# Environmental Review Team Report

Environmental Review Team  
Report  
on

October 1980

## SCHEMATIC DESIGN

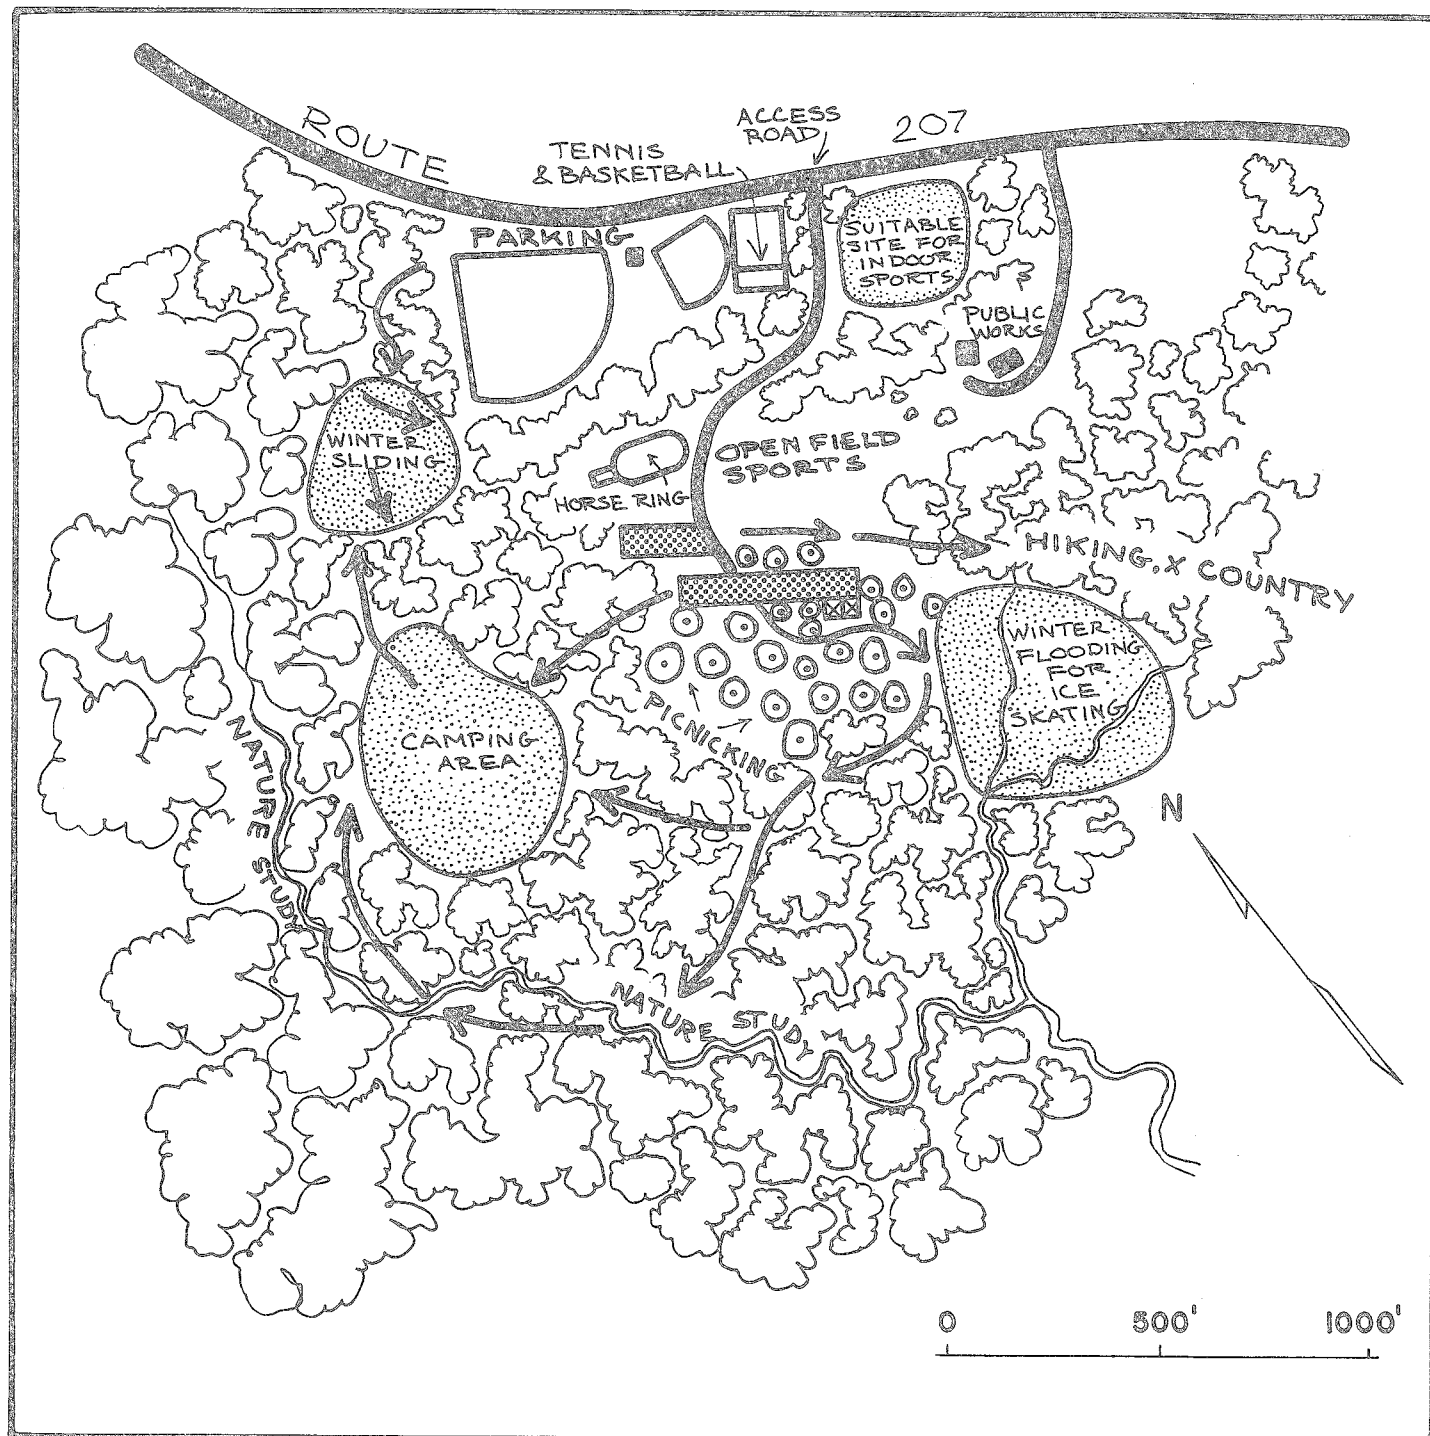
A sketch plan of a possible facilities layout is included in this report for the Town's consideration. This schematic plan allows for all feasible activities proposed by the town and also takes environmental limitations and cost factors into consideration. The Town may wish to revise its proposed plan to reflect information about environmental restrictions provided by this study.
